VALUE ENGINEERING STUDY

**Project # STP00-0065-02(013) PI No. 621490-
SR 53 Bu from SR 515/APD to CR 243/Industrial Blvd
Pickens County, Georgia**

Reference: VE Workshop – SR 53 Bu from SR 515/APD to CR 243/Industrial Blvd.,
Pickens County, GA
Project #: STP00-0065-02(013) - PI#: 621490-

PROPOSED CHANGE SKETCH/DETAIL

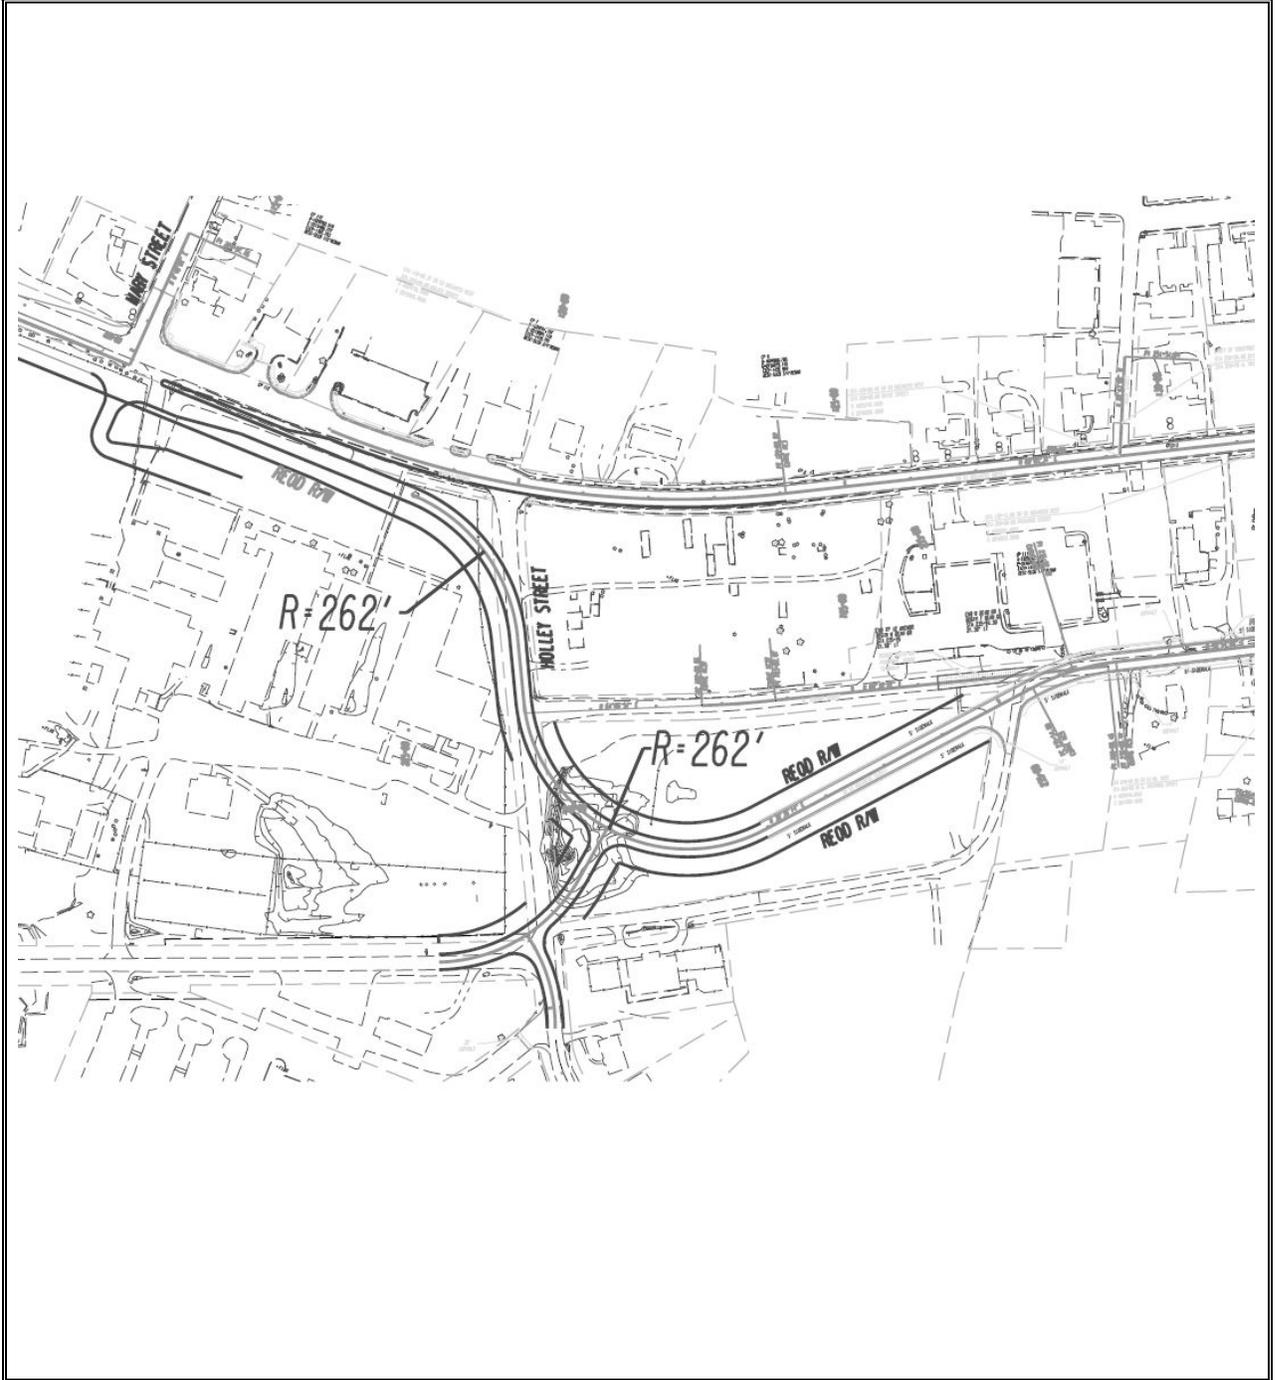
PROPOSED CHANGE: The proposed change relocates the split Eastward to begin at Mary Street, eliminates the new location for the Eastbound pair (on the South side of the school) and utilizes the existing street network. The change includes one signalized intersection at Mary Street and also at the relocated middle school driveway. Design is based on a 30 MPH alignment with 4% e_{max} .

JUSTIFICATION: The new location alignment for the Eastbound pair, which impacts rural properties and the school, can be eliminated and still meet the purpose and need for the project.

PROPOSED CHANGE SKETCH/DETAIL

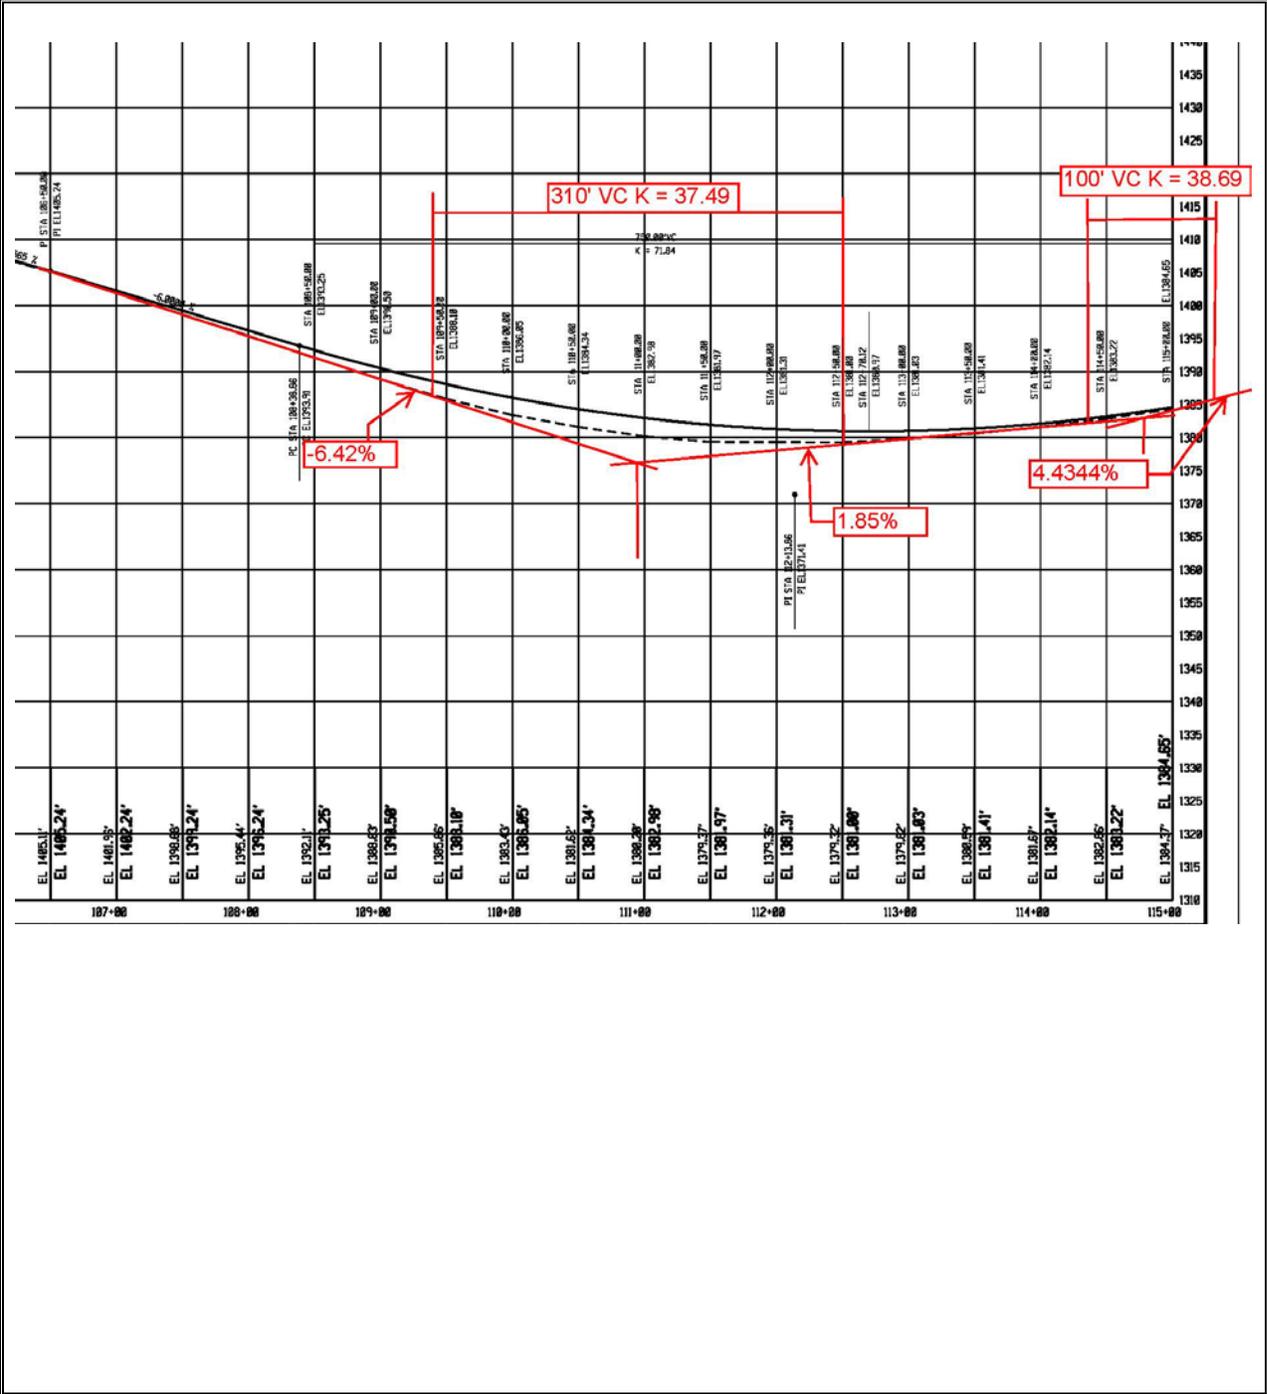
PROPOSED CHANGE: It is proposed to change the approach grade from 6% to 6.42% to match the existing grade and create two small vertical curves to more closely match the existing. The first curve will be approximately 310 ft. in length with the PVI at station 110+95 and the second curve will be approximately 100 ft. in length with the PVI at station 114+80. Both curves meet the design speed of 30 MPH required for the one-way pairs. This vertical change will minimize the length of the culvert extension and reduce P3 walls to P2 walls and some P2 walls to P1 walls.

JUSTIFICATION: Per the GDOT Design Policy Manual Section 4.3.2, maximum grades can increase by 1% for short sections less than 500 ft. and one way downgrades - this section of the roadway meets both of these criteria. Adjusting the approach grades allows the proposed grade to more closely follow the existing grade and therefore minimize property impacts, reducing wall heights and construction fill heights, and enhancing constructibility (staging).

PROPOSED CHANGE SKETCH/DETAIL

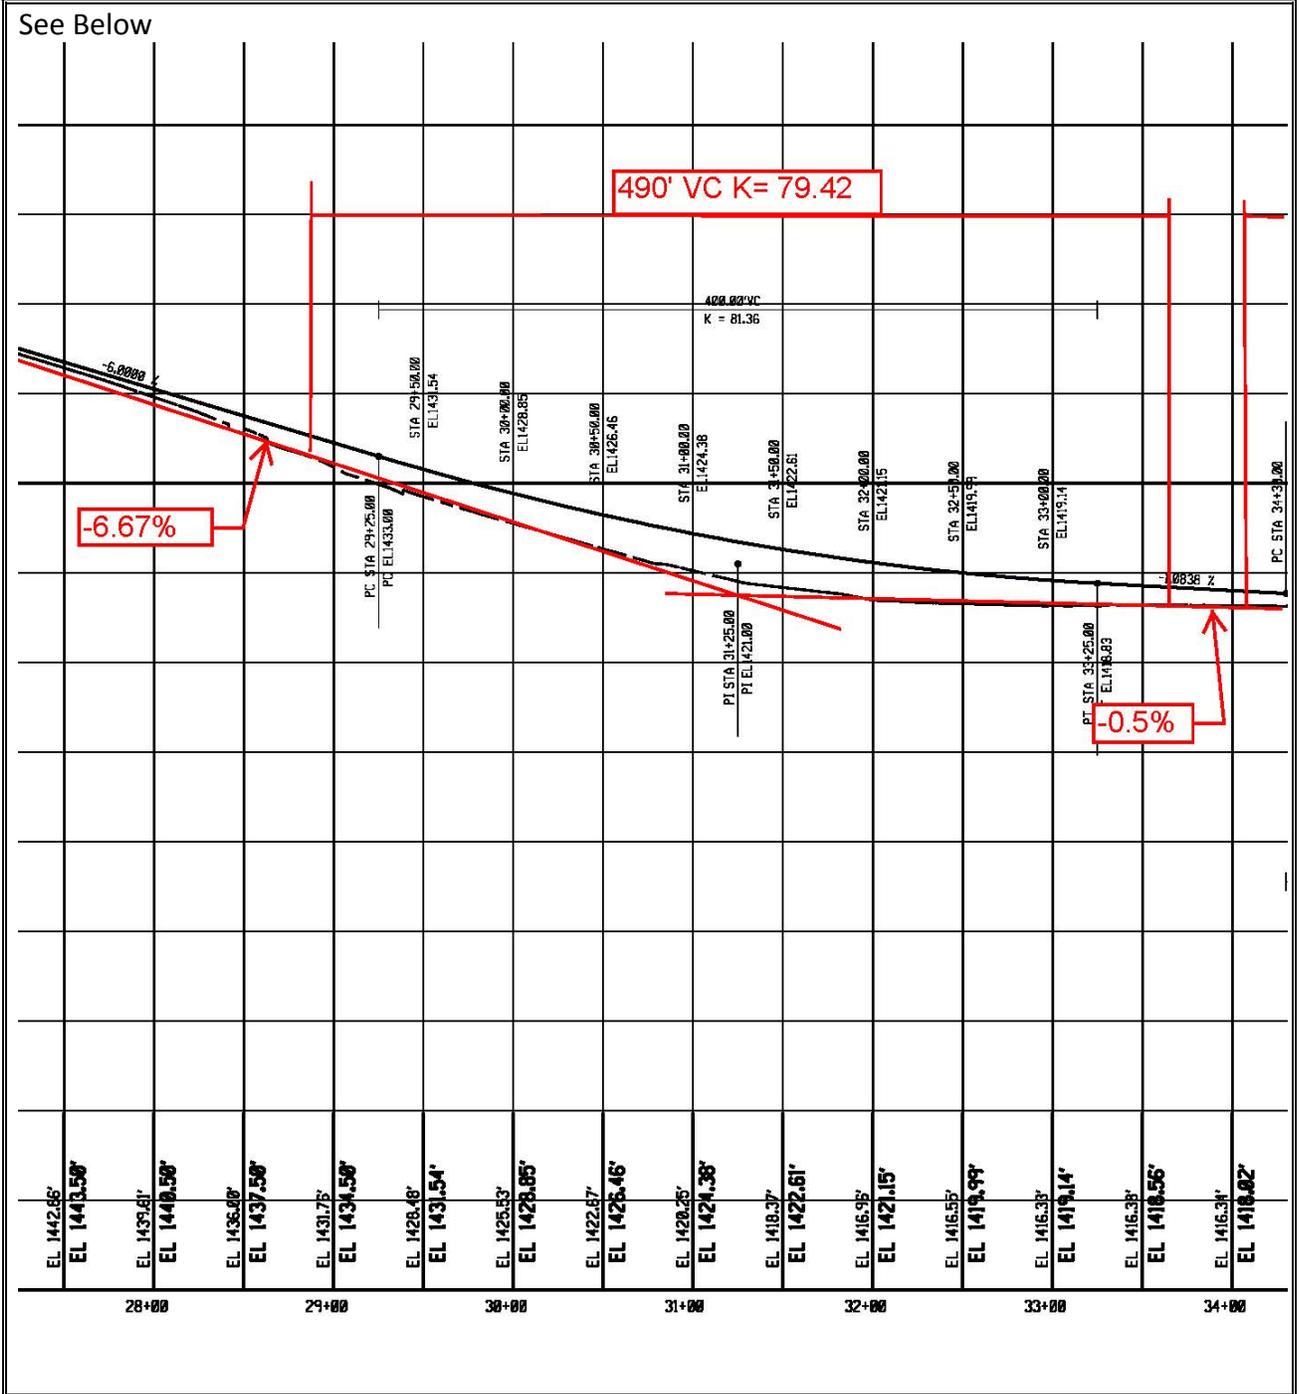
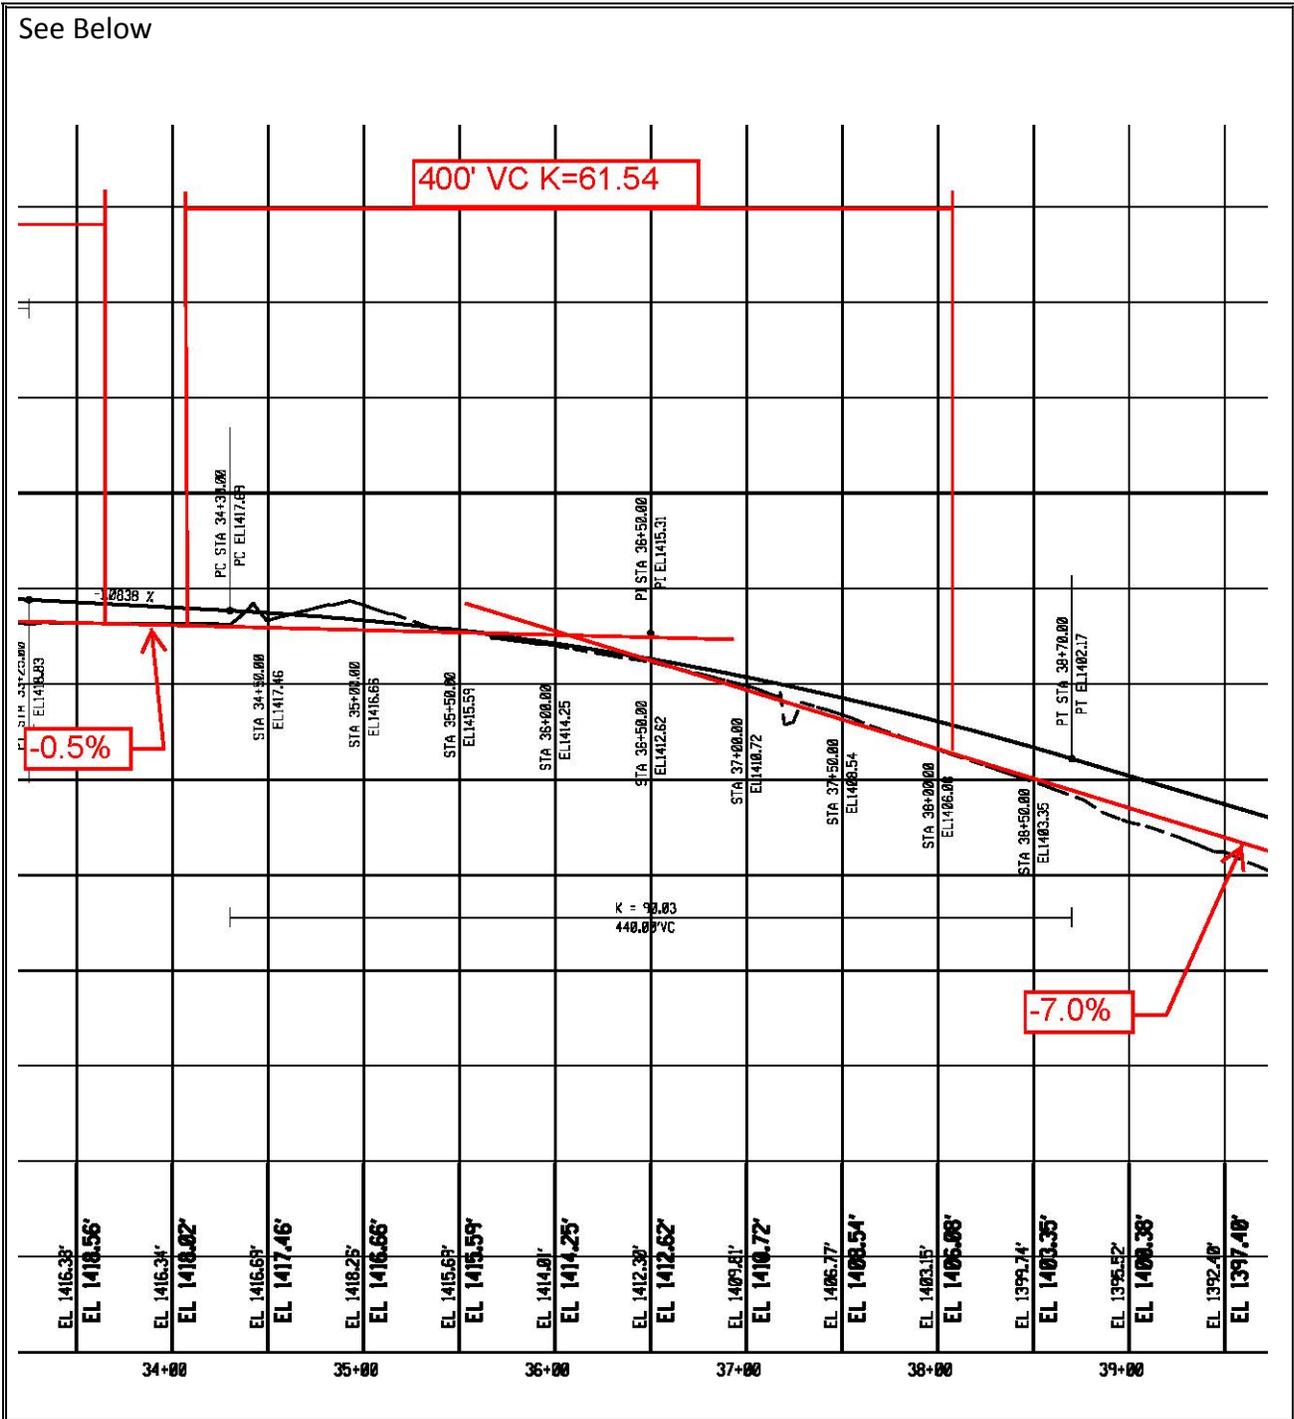
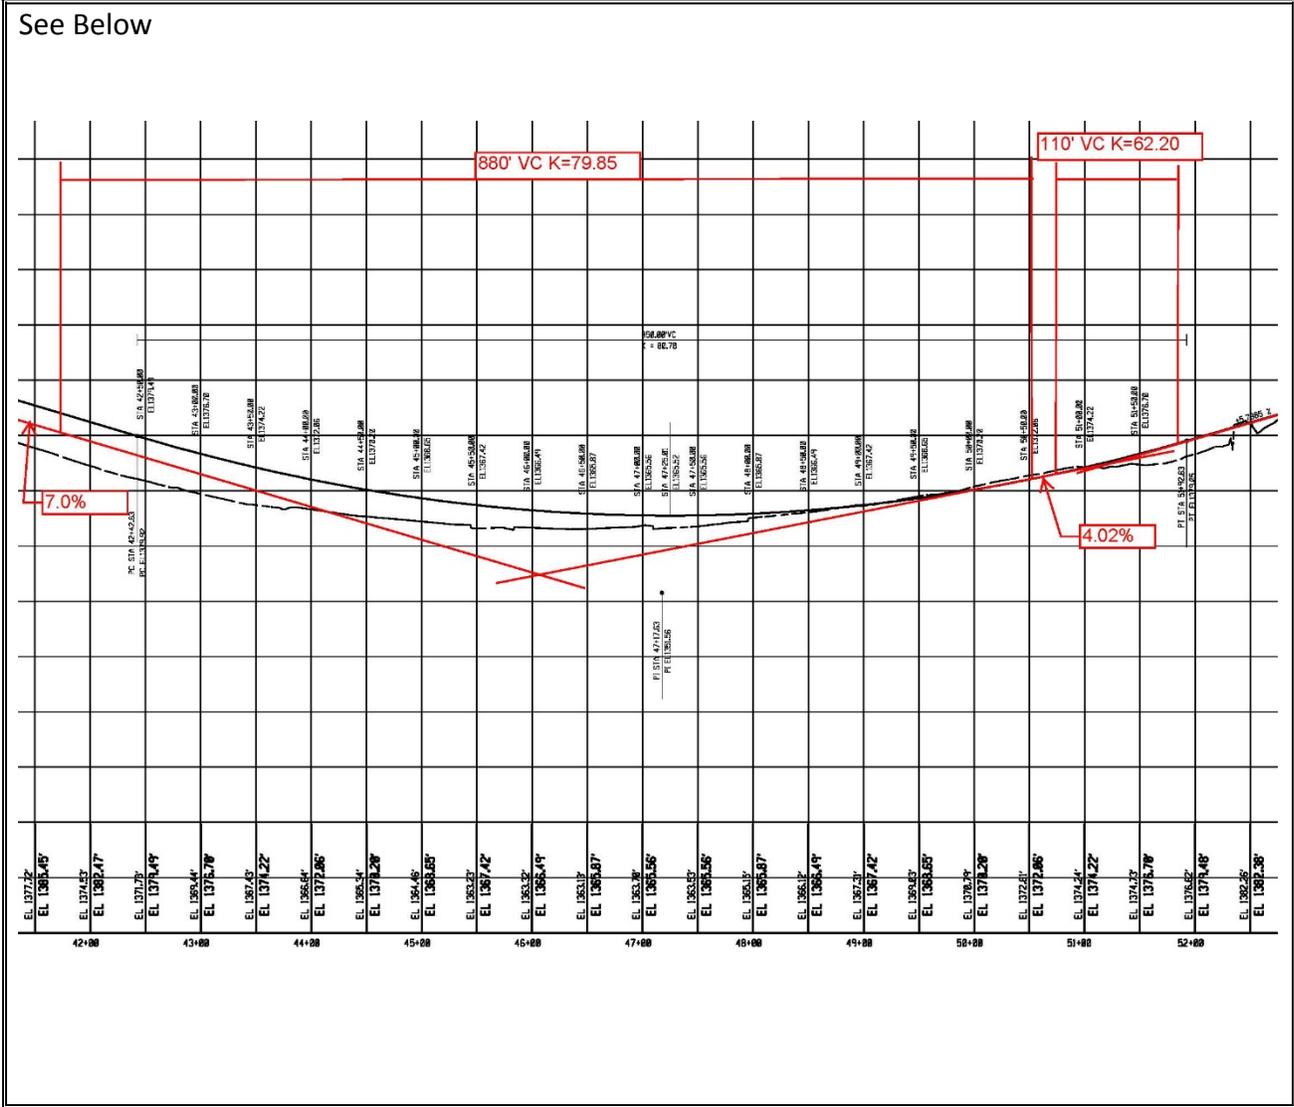
PROPOSED CHANGE: It is proposed to change the approach grade of the first curve from 6% to 6.67% to more closely match the existing grade coming from SR 515. The PI at Sta 31+25 will remain at about the same location but will be lowered in elevation by approximately 4 ft. to 1417. The PI at Sta 36+50 will move to approximately Sta 36+10 at the same elevation as the existing PI of the curve. The exiting of the 2nd curve and the approach of the 3rd curve are raised from 5.97% to 7.0 % grade. The PI at Sta 47+17.63 will move to about Sta 46+15 with an elevation of approximately 1355. A new 110 ft. vertical curve is added at Sta 51+25.

JUSTIFICATION: Per the GDOT Design Policy Manual Section 4.3.2, maximum grades can increase by 1% for short sections less than 500 ft. and one way downgrades - this section of the roadway where grade changes proposed over 6% are to be utilized are less than 500 ft. in length. Increasing the maximum grades to 7% allows the proposed grades to more closely follow the existing grade, minimizing property impacts, and reducing wall and fill heights.

PROPOSED CHANGE SKETCH/DETAIL

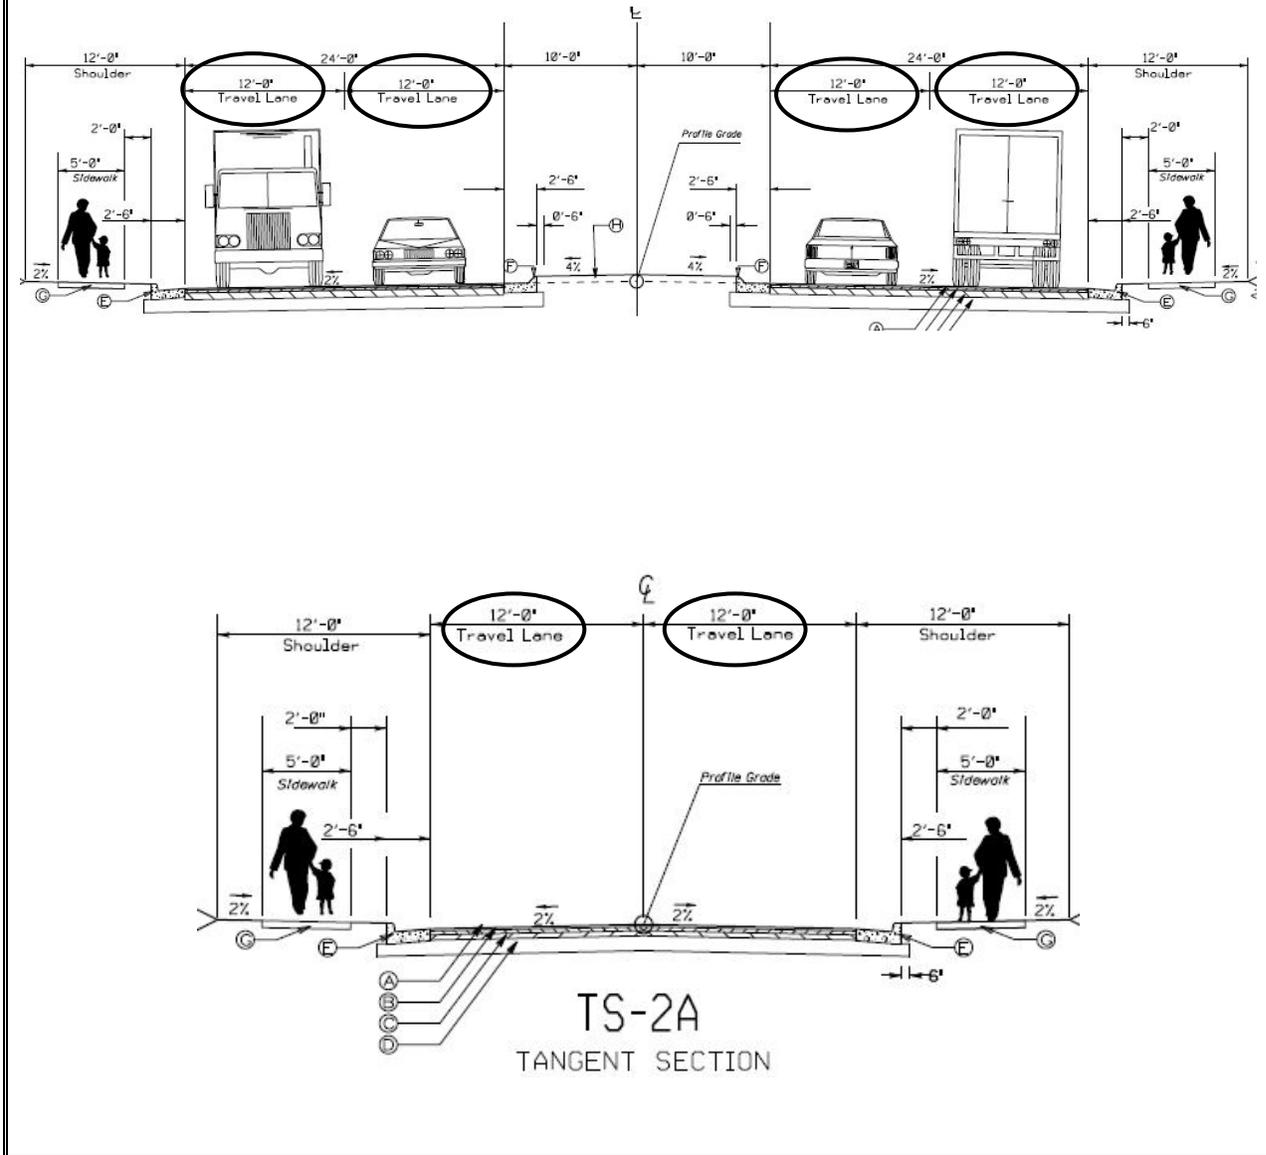
PROPOSED CHANGE: It is proposed to reduce the proposed lane widths from 12' to 11' lanes. For most locations, the basic approach would be to maintain the proposed north edge of pavement and move the south edge in. This change reduces four feet of paving along the proposed four lane section and two feet along both SR 53 BUS East and West until the tie-in with the existing sidewalk section where the paving will consist of overlay of the existing pavement.

JUSTIFICATION: Truck volumes are low at 5% with 45 and 30 MPH design speeds. Also, the horizontal alignment has one minor curve prior to the split. Moving the south edge will reduce the proposed ROW a minimum of 4 to 8 ft. The 11' lane width is acceptable for roadways in this project which are less than 50 MPH with low truck volumes.

Proposed Change: Revise 12'0" lanes to 11'0"
